Additional Information not included in SLR's Flood Risk and Surface Water Management Statement Version 2 dated May 2022

Relevant Extracts from SLR's May 2022 Flood Risk Assessment Report On Groundwater Flooding that the committee report is referring to (para 17.12)

JACOBS			
CLIENT EPSOM & EWELL BOROUGH COUNCIL			
PROJECT Epsom and Ewell SFRA			
TITLE Historic Flooding			
DRG No Figure 104			
SCALE NTS		DATE 08/05/2018	
CW DRN	MS CHK'D	MS REWD	RC APR'VD

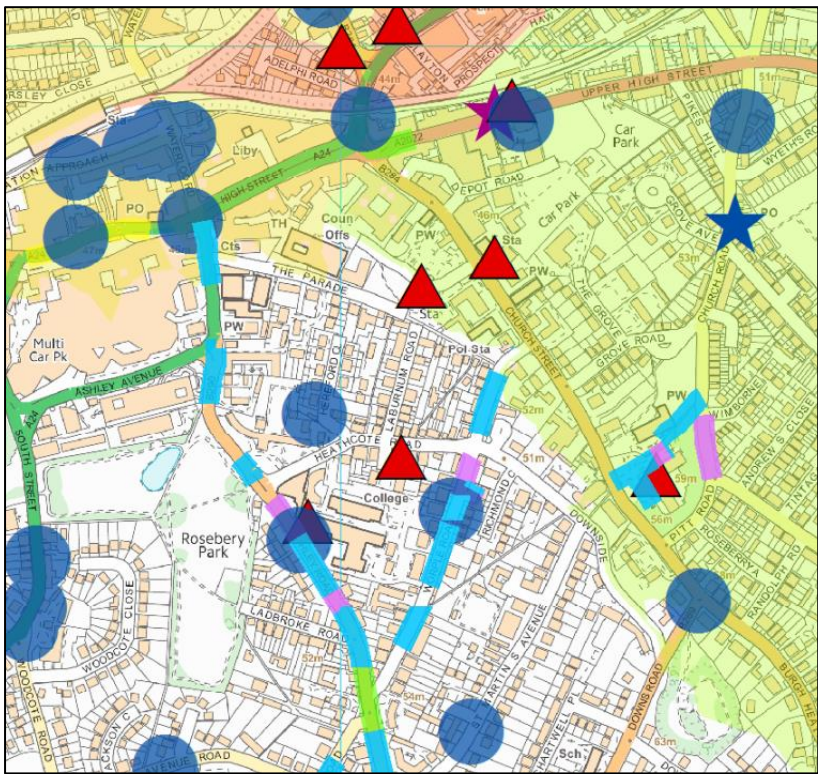
Jacob's **Groundwater Emergence Map(GEM)** is shown in **Figure 110** below. The diagonal shaded areas are the Groundwater Emergence Zone and the area around The Parade has $\geq 25\%$ risk of AStGWF (Areas Susceptible to Groundwater Flooding) shown as yellow dots. Richmond Council requires a Basement Screening Assessment as part of a Planning Application process - not as a Condition.

Figure 4: Site Context (Extract from Surface Water Drainage Strategy)

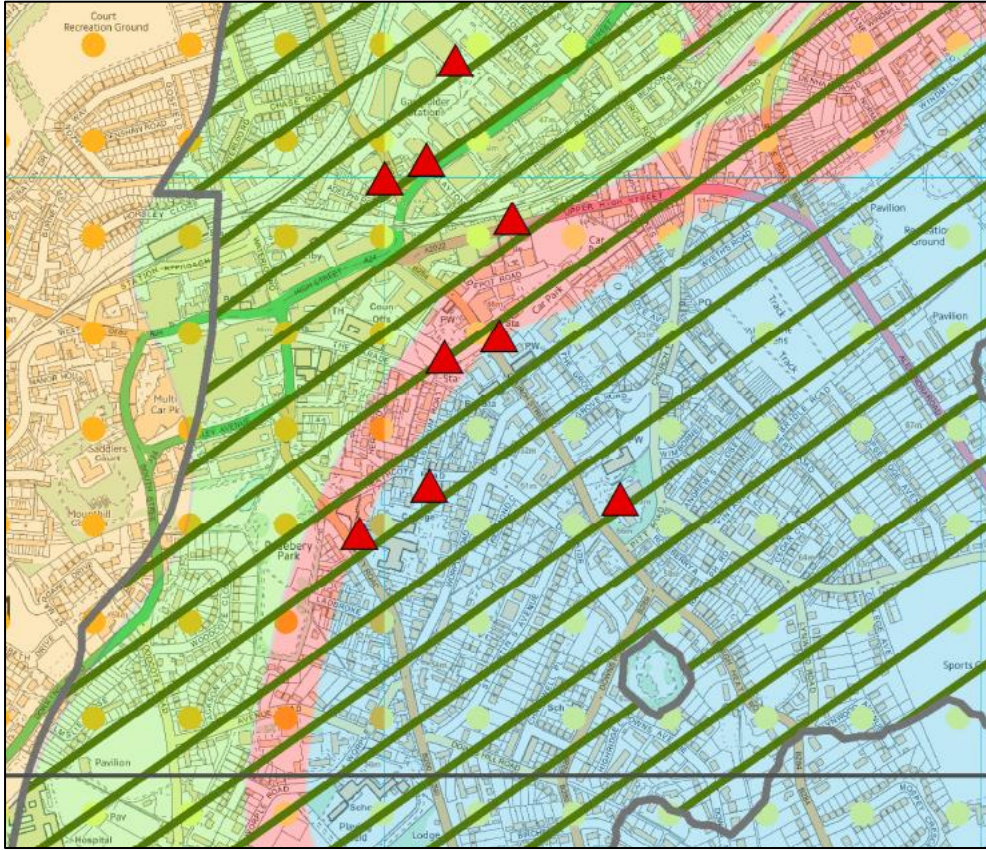
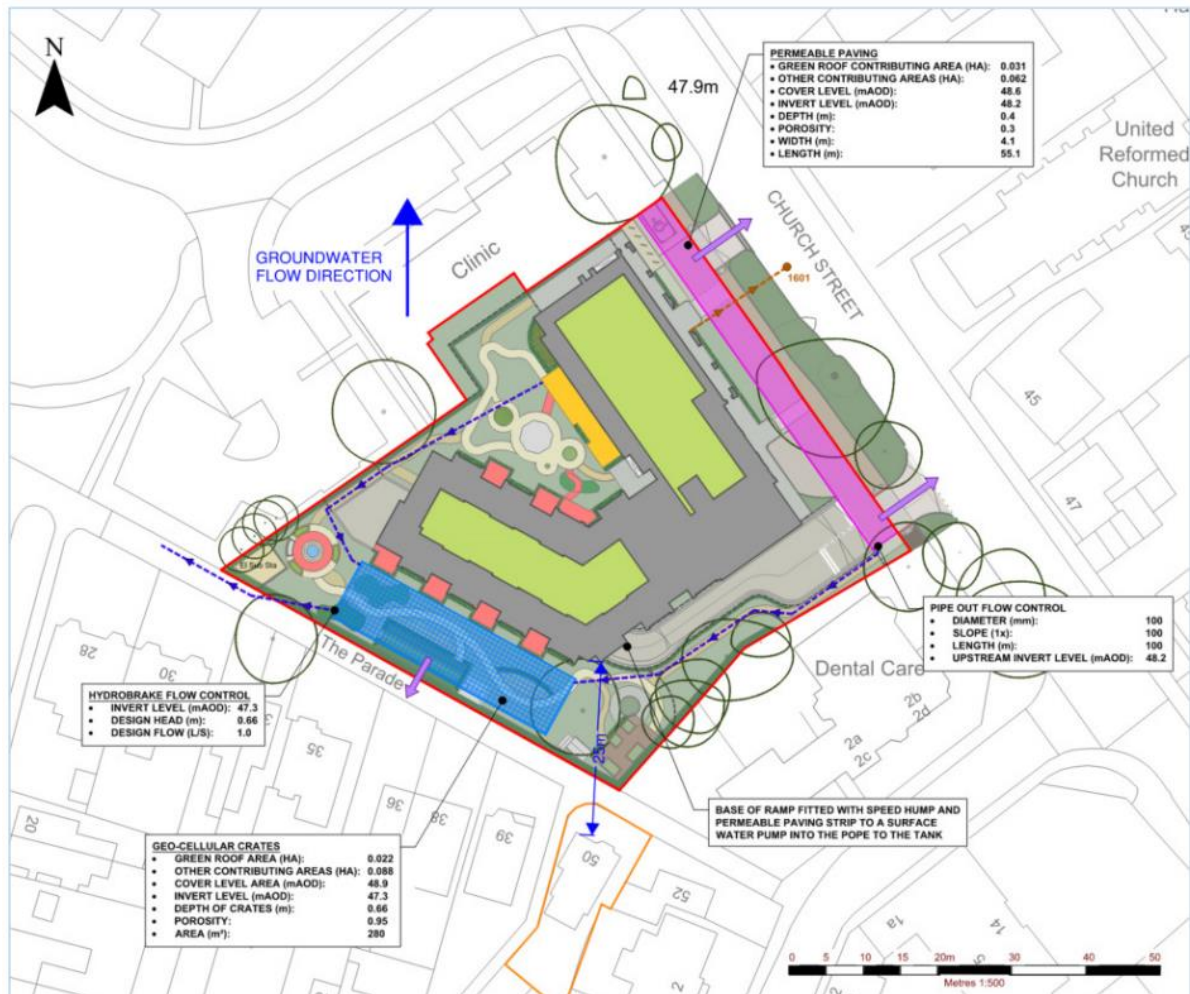
Care home proposal showing position of basement car park in dark grey (footprint of building) plus attenuation tank (in blue) located between the basement car park and The Parade. Also showing assumed groundwater flow direction and distance of proposed basement from our house. NB the attenuation tank is even closer than the basement car park.
